As-Built Baseline Monitoring Report
FINAL VERSION
Horne Creek Tributaries Mitigation Project
Monitoring Year 0
Calendar Year of Data Collection: 2020

NCDEQ DMS Project Identification # 100026
NCDEQ DMS Contract # 7181
Yadkin River Basin (Cataloging Unit 03040101)
USACE Action ID Number: SAW-2017-01510
NCDEQ DWR Project # 2017-1156
Surry County, NC
Contracted Under RFP # 16-006993
Data Collection Period: May 2020
Submission Date: August 2020

RE: WLS Responses to NCDEQ DMS Review Comments for Task 6 Submittal, Draft Baseline Monitoring Report for the Horne Creek Tributaries Mitigation Project, DMS Full-Delivery Project ID #100026, Contract #7181, Yadkin River Basin, Cataloging Unit 03040101, Surry County, NC

**FIGURE
1**

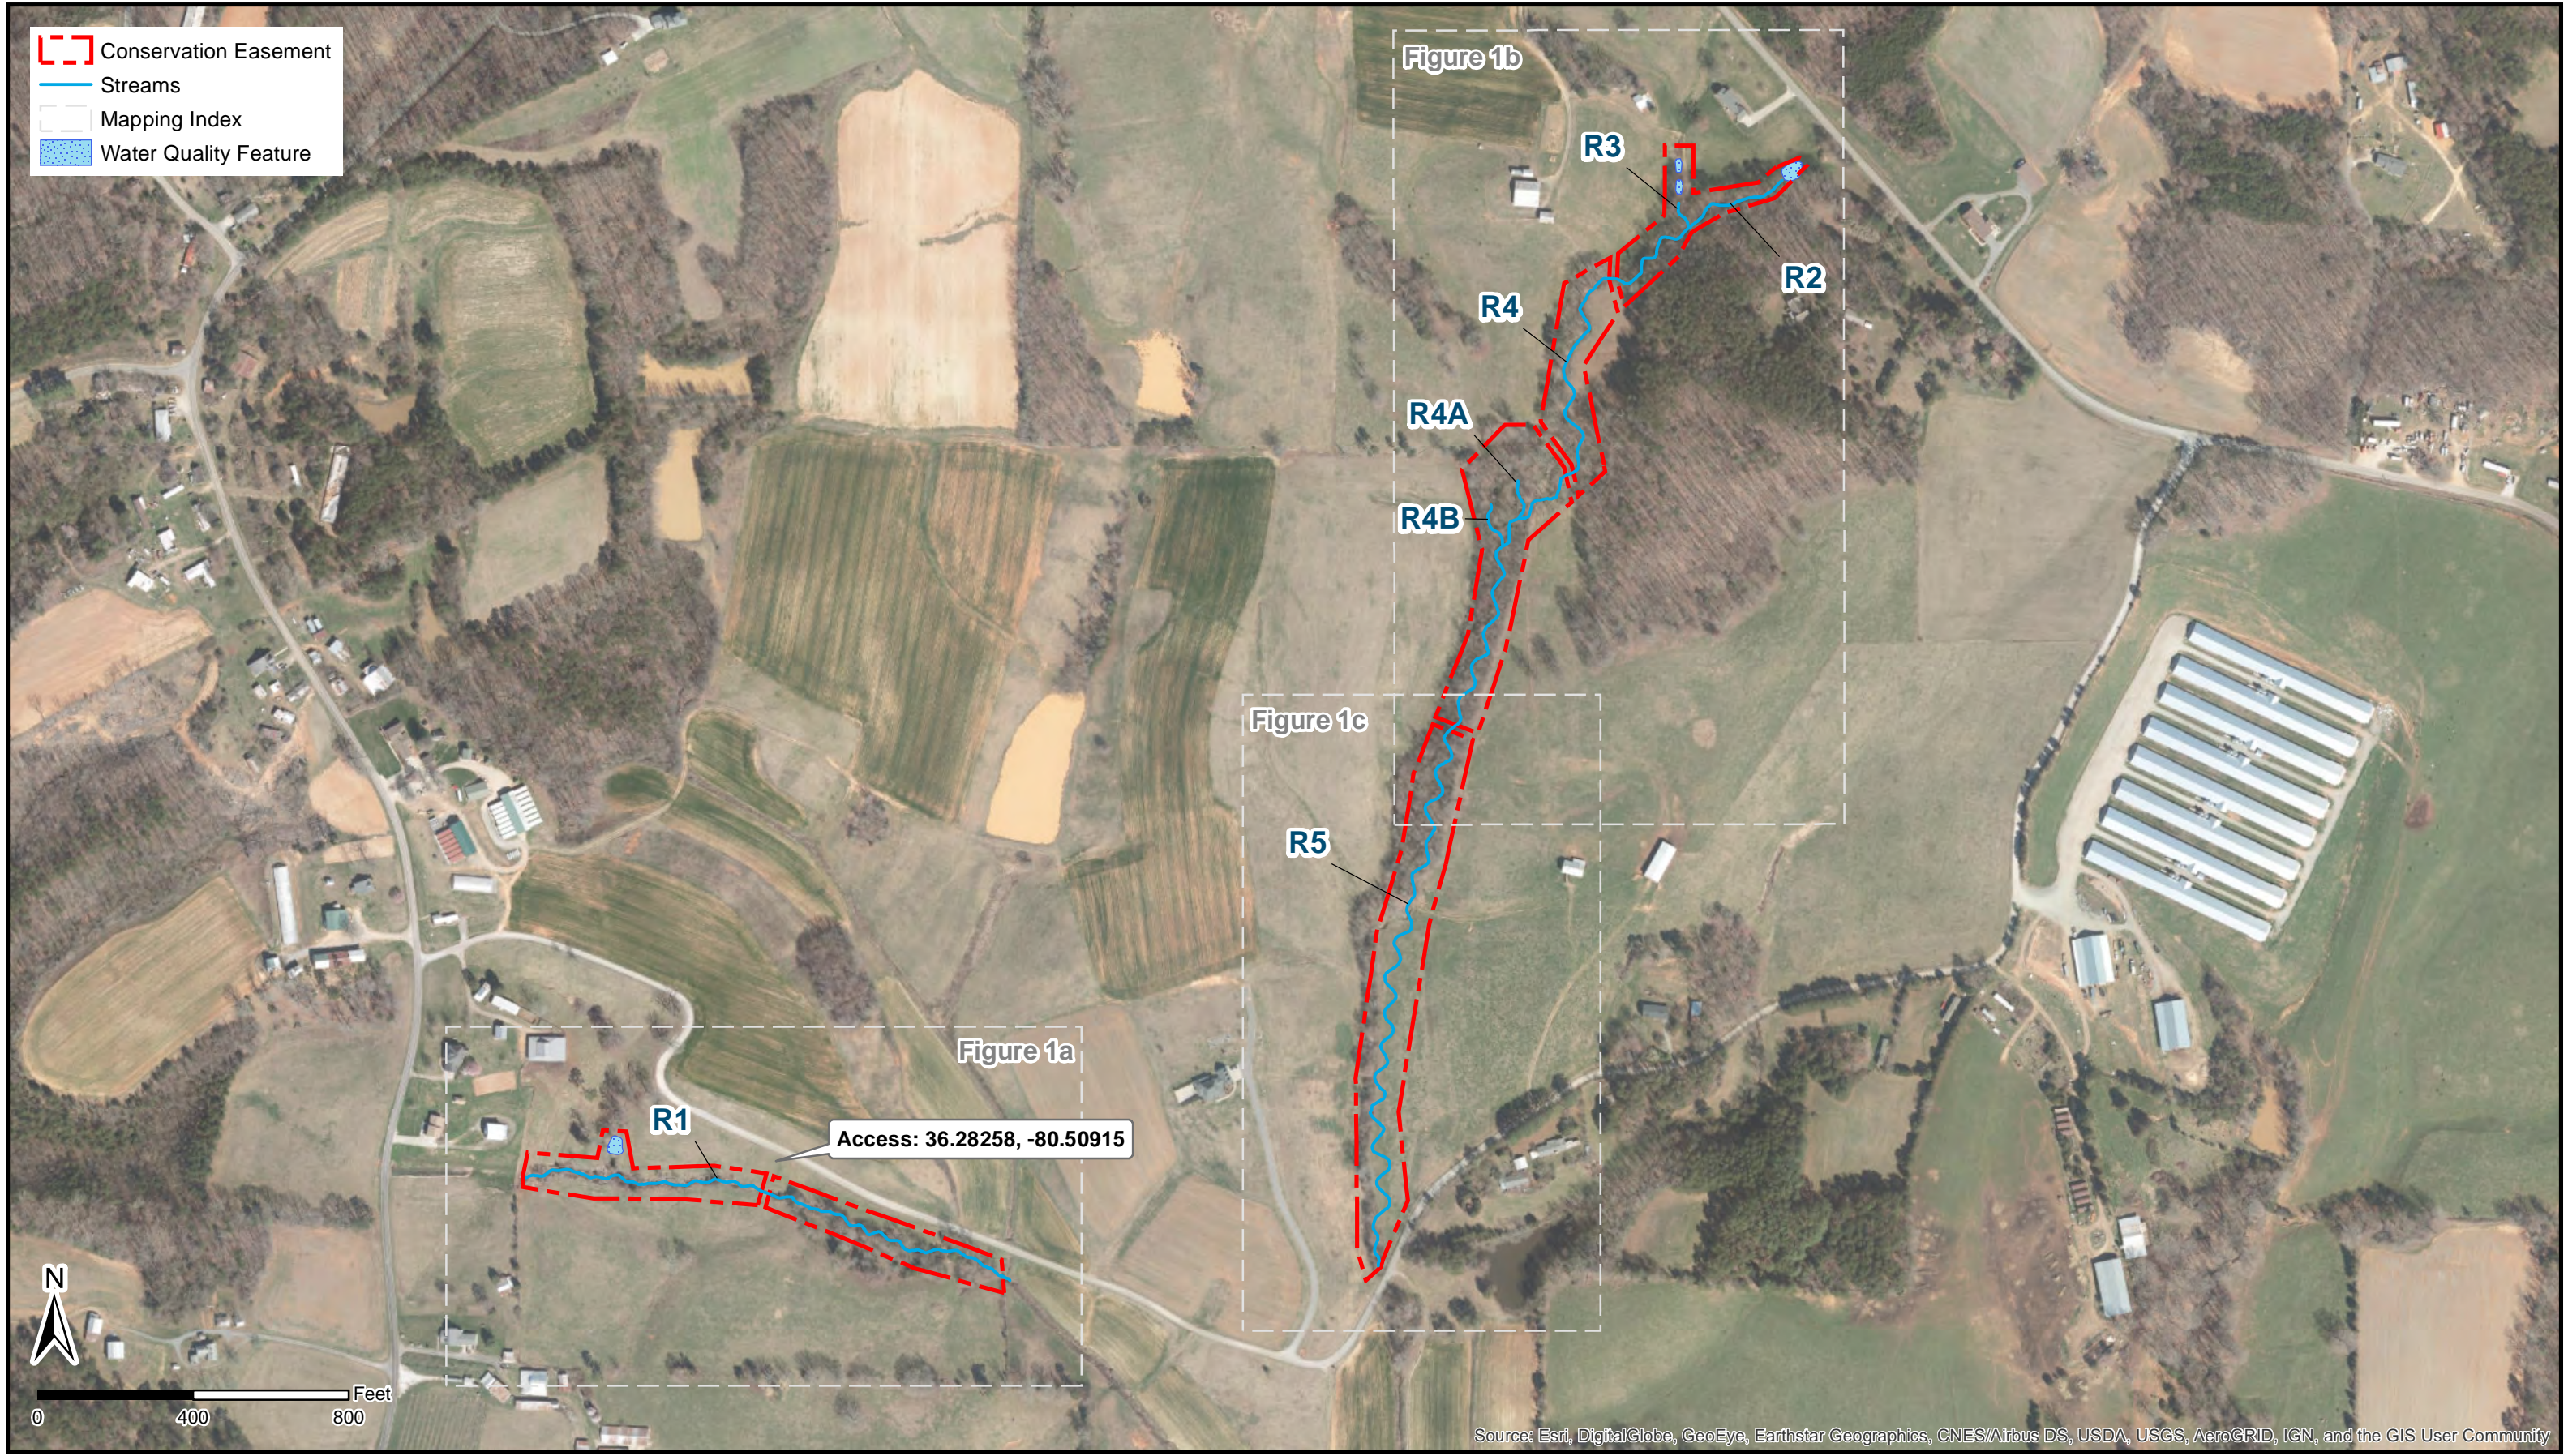
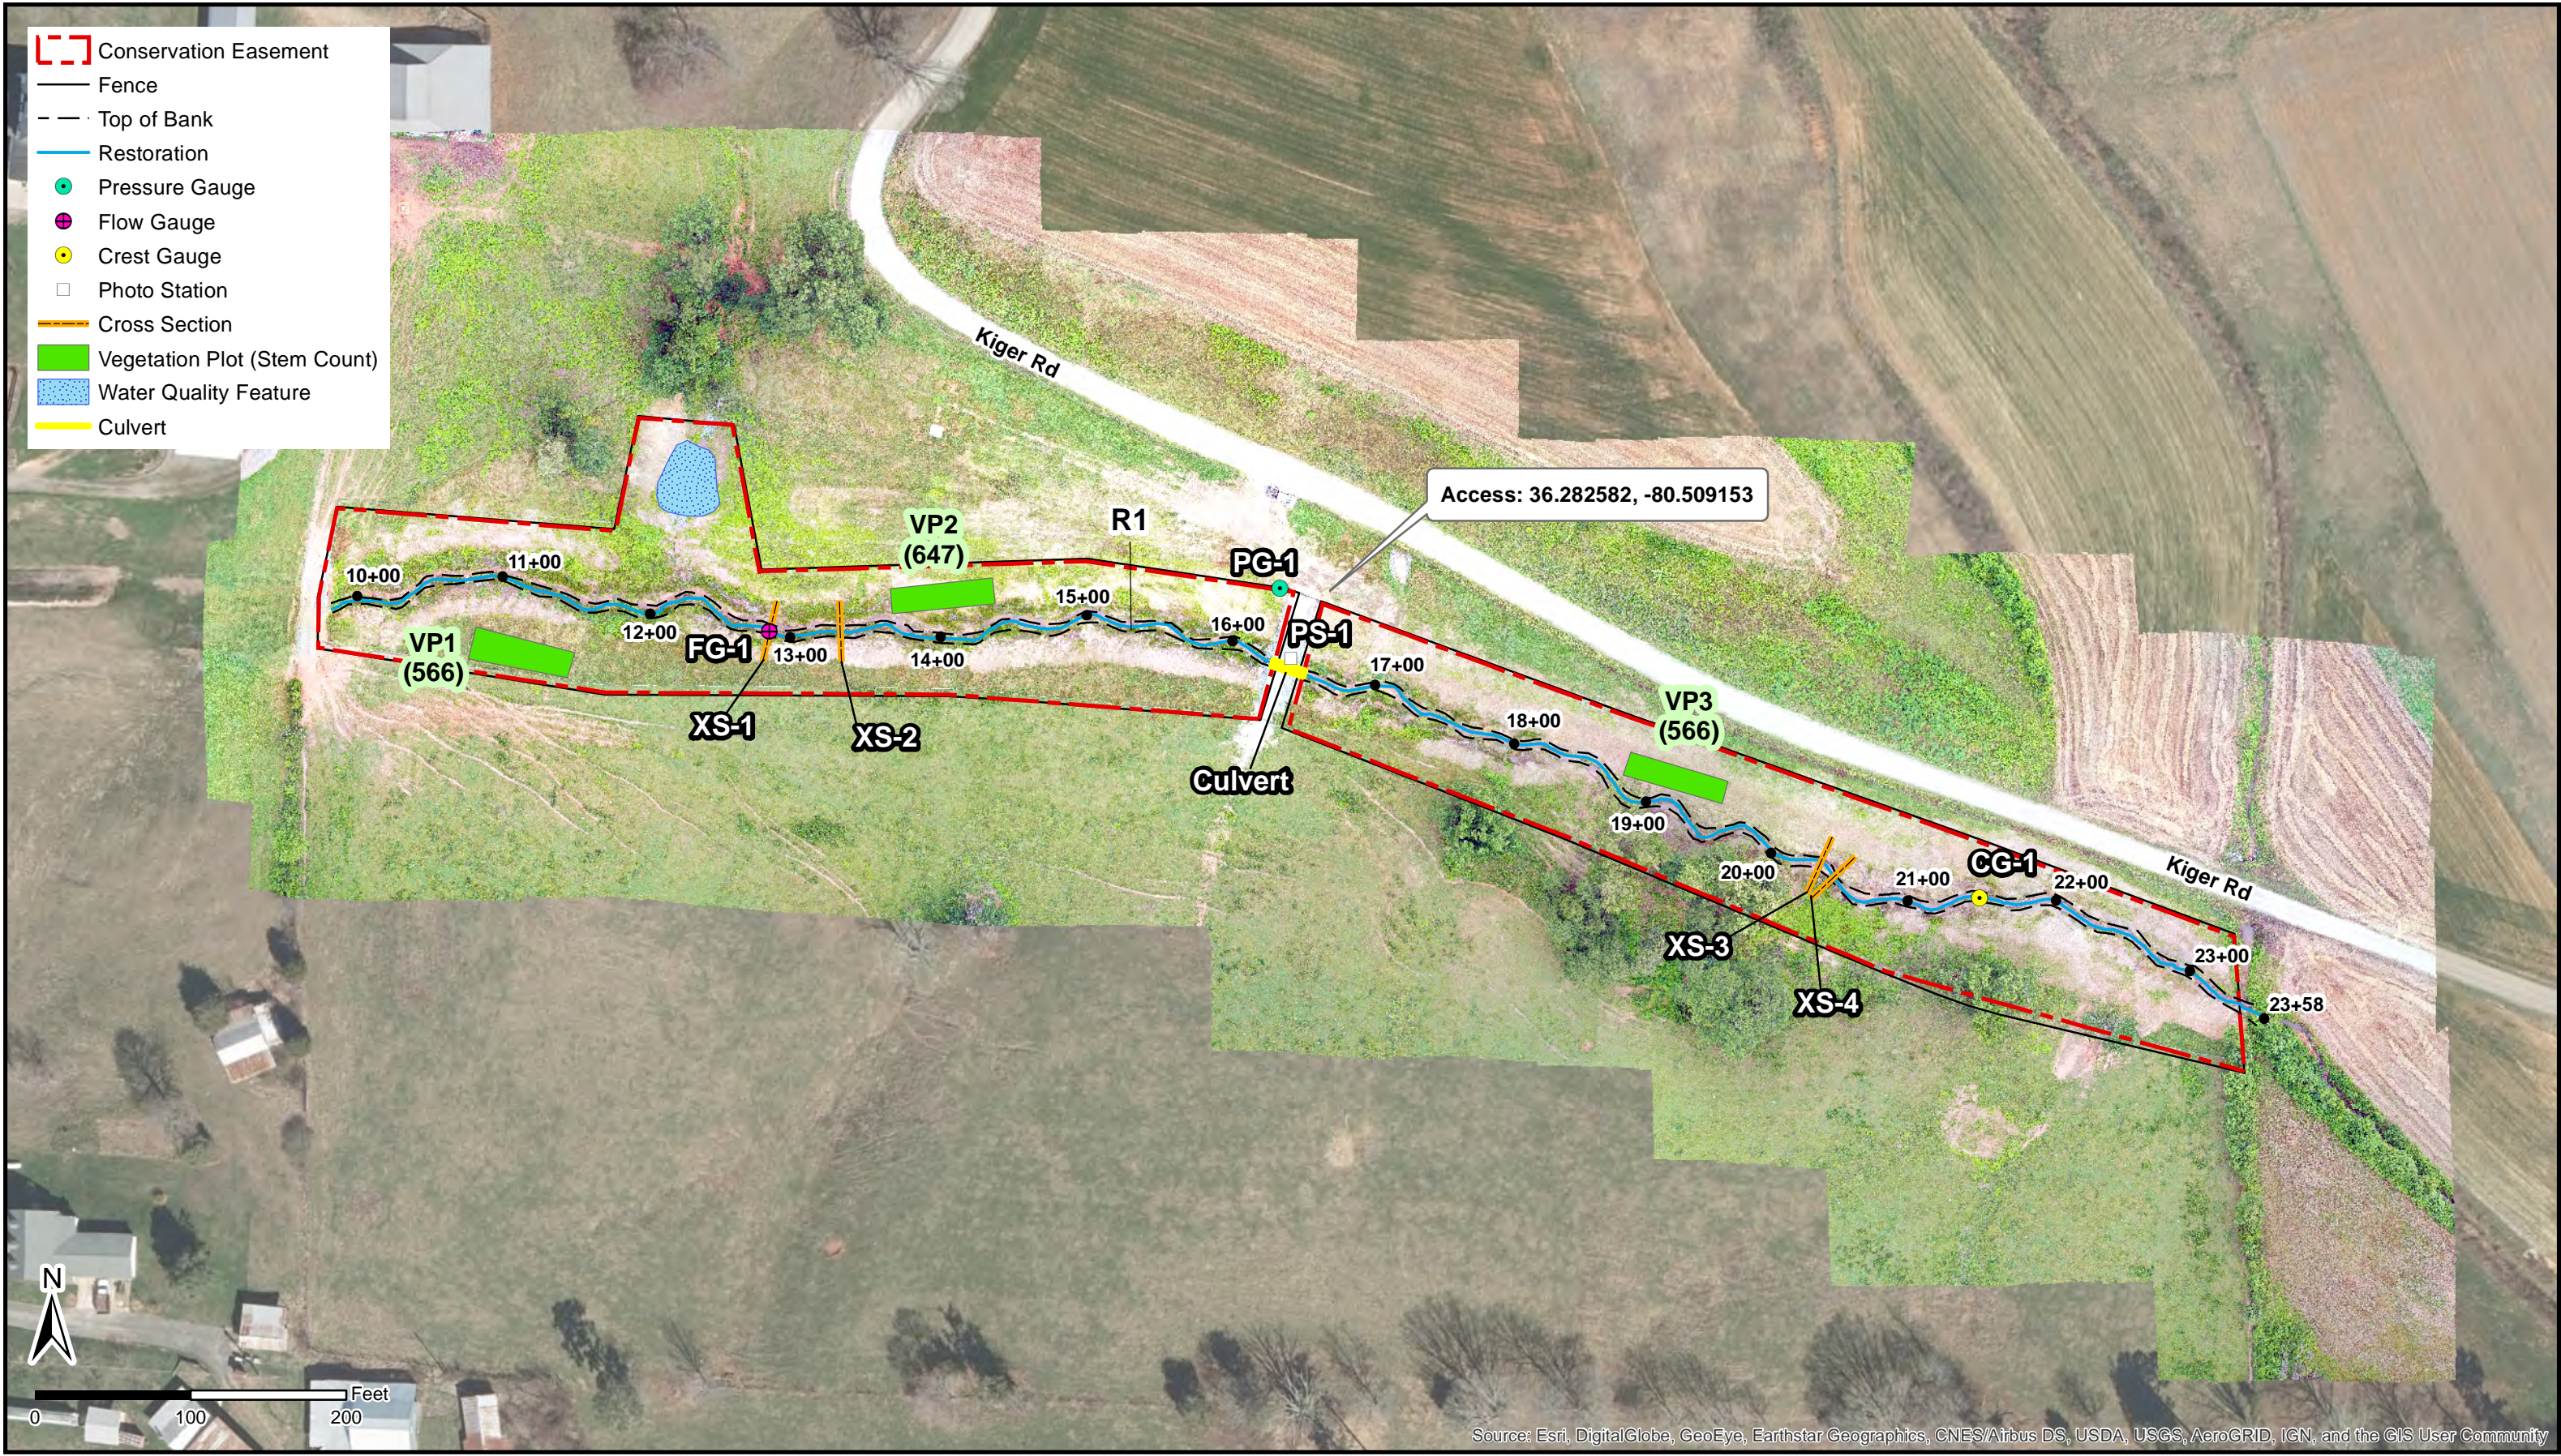
- **CCPV: Please add an overview map that shows both project streams in relation to one another.** WLS Response: An overview map displaying all project reaches was created and added to the CCPV.

- **CCPV: Please include stationing. When photo points are added in MY1, please include these locations on the CCPV.** WLS Response: Stream stationing and photo points have been added to the CCPV.
